Landscape Referral Response

Application Number:	DA2025/0082
Date:	27/02/2025
Proposed Development:	Demolition works and construction of a dual occupancy (attached), swimming pool and strata subdivision
Responsible Officer:	Jordan Howard
Land to be developed (Address):	Lot 19 DP 17127 , 33 Undercliff Road FRESHWATER NSW 2096

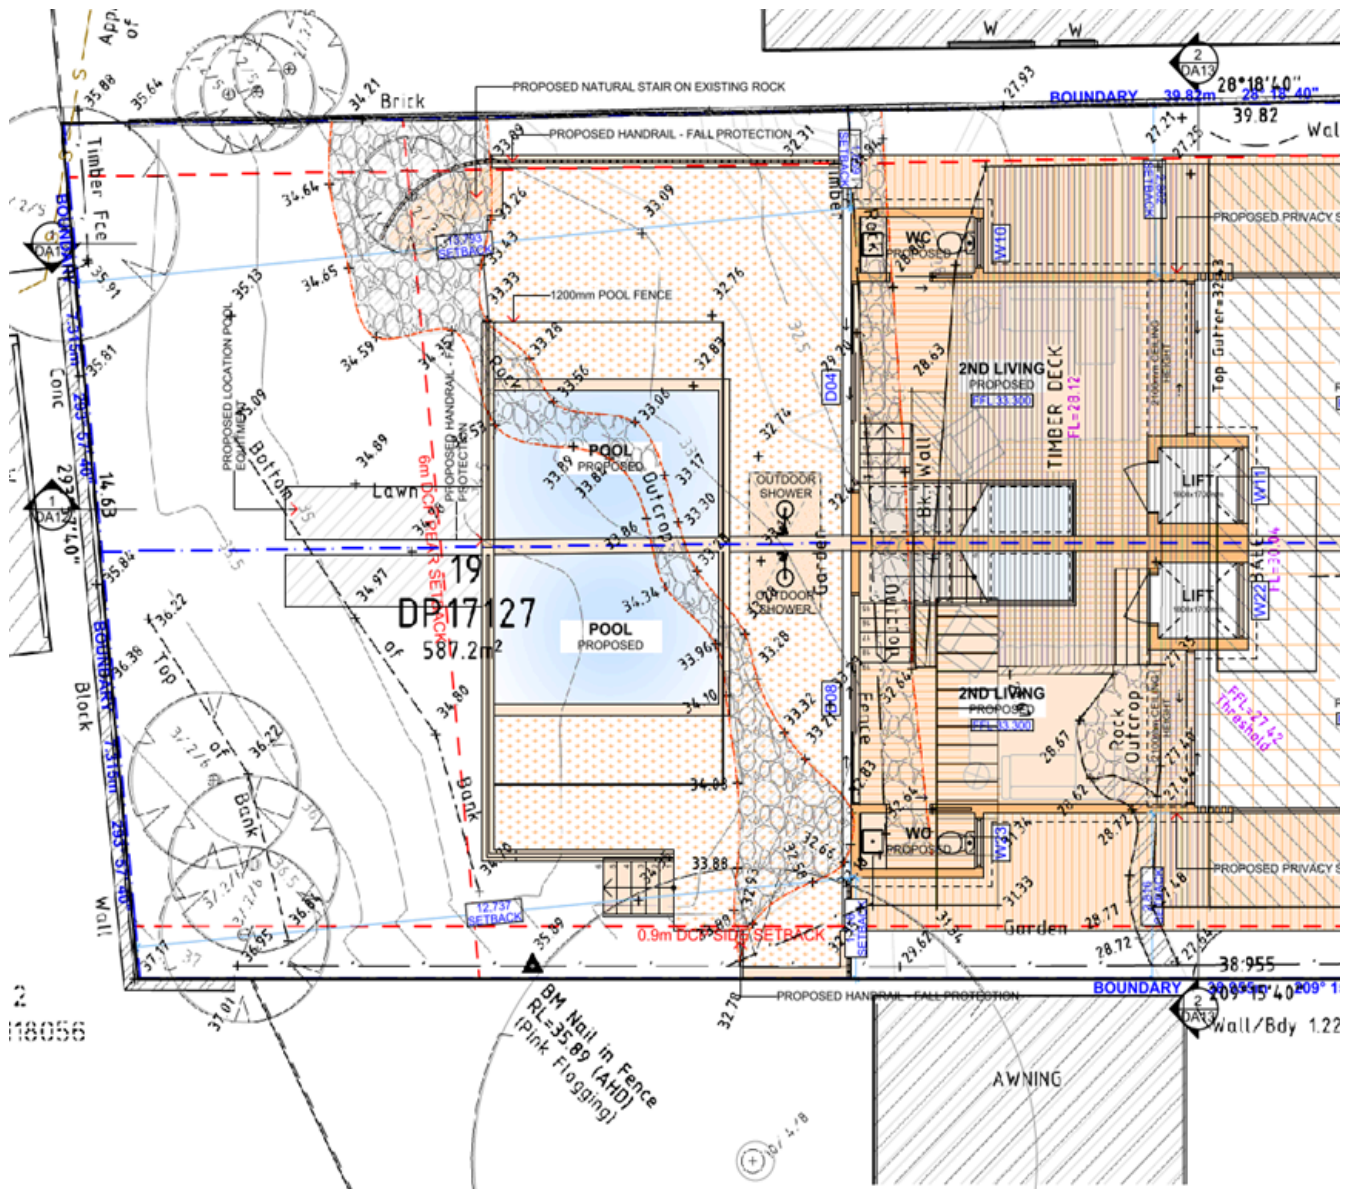
The plans indicate that excavation of the escarpment will be required to accommodate the buildings, pool and landscape area at the rear of the dwellings.

The plans indicate that the rear terrace containing swimming pools is proposed at RL 33.30, and that levelled turf areas surround the pool.

The overlay of the survey plan and the Second Floor Plan (Dwg. DA09) indicate that this would remove the rock overhang and escarpment (Fig.1).

Fig.3 Area at the rear of the site to be landscaped in harmony with existing natural features and excavation avoided shown in red..

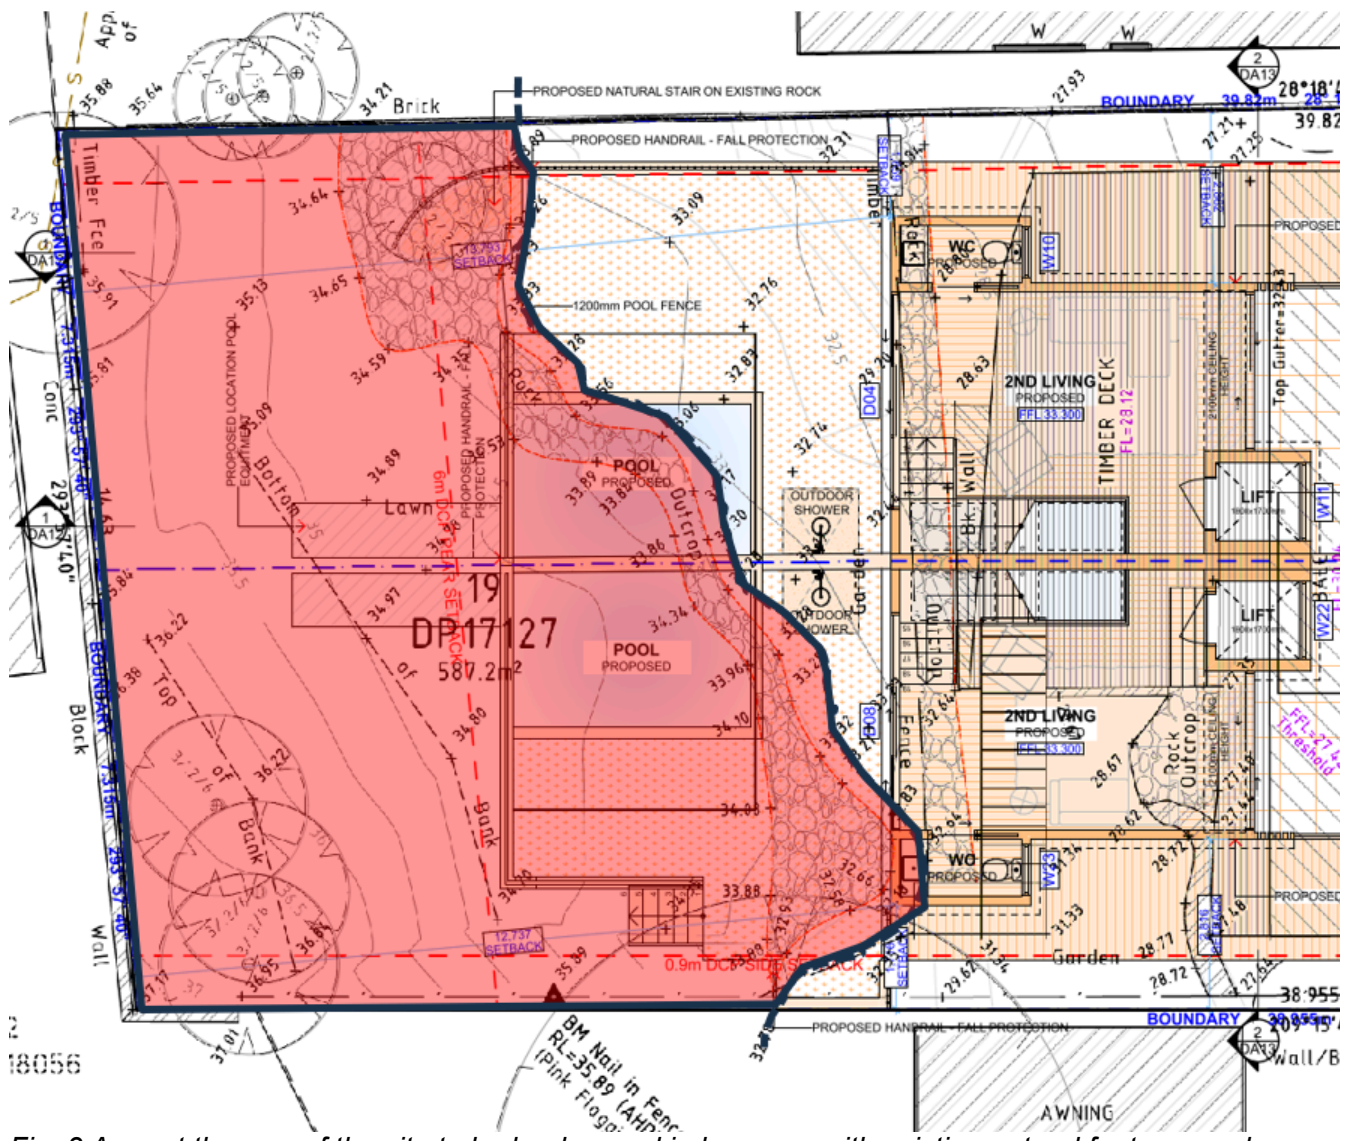
It is recommended that the proposal be redesigned to ensure protection of the rock escarpment and that ancillary works in the rear of the buildings be designed in harmony with the natural features of the site. No excavation should occur within the portion of the site to the south of the escarpment. (Figs. 3 and 4).

Fig. 4 Building works to avoid removal of the rock escarpment.

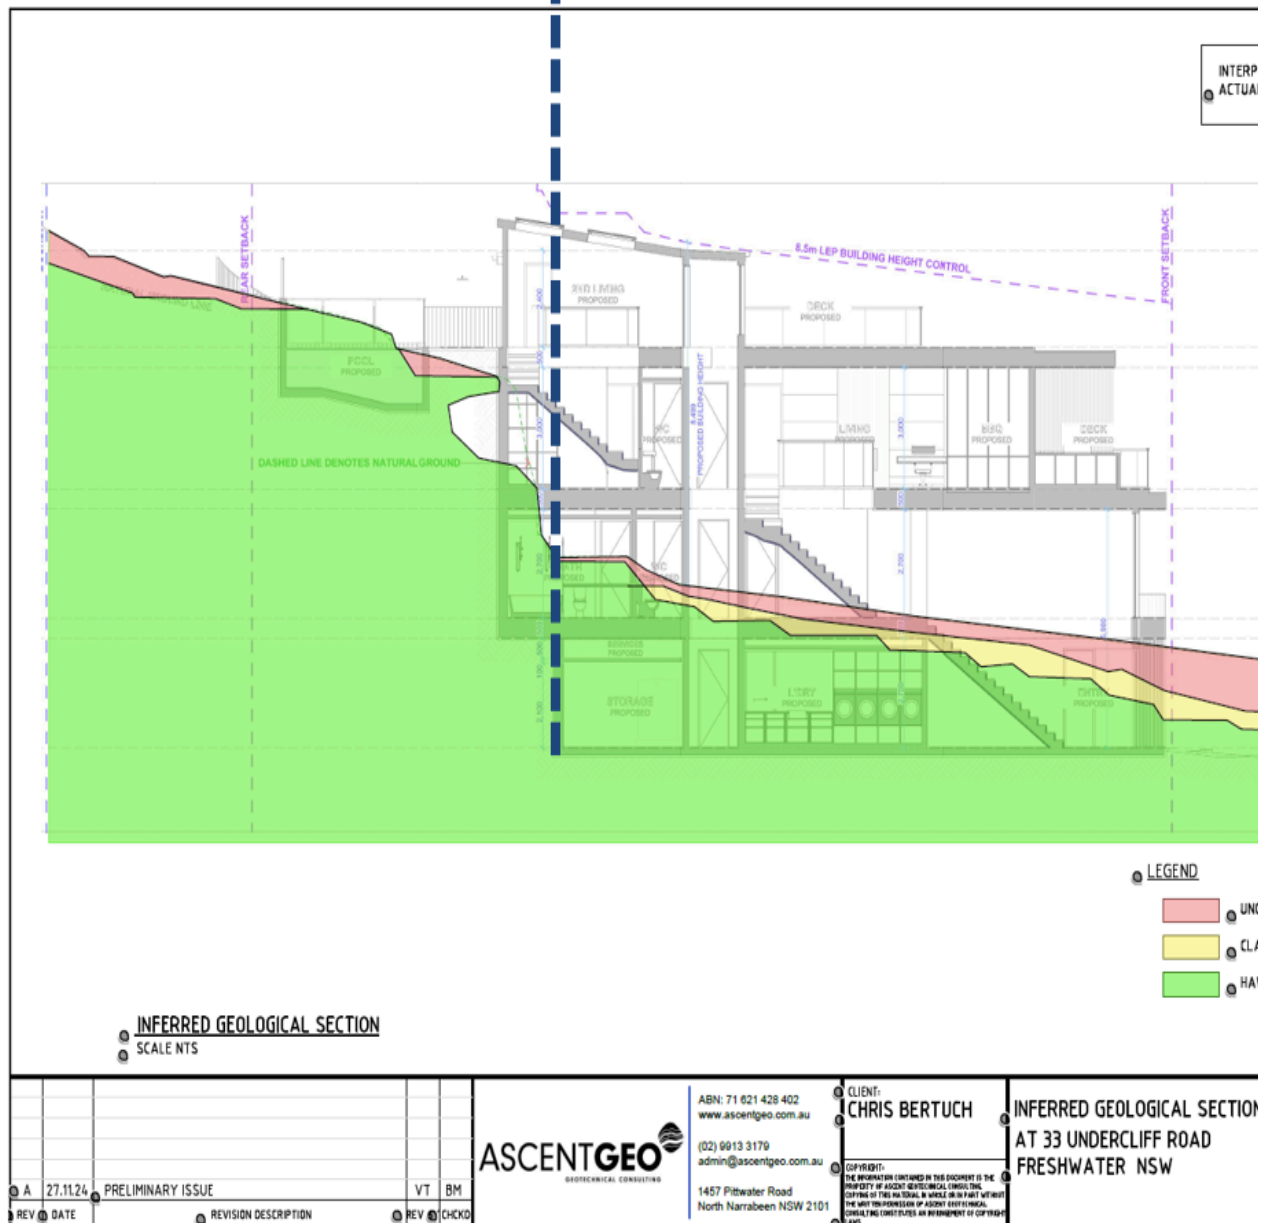
Excavation must avoid removal of or impacts to exposed natural rock escarpment
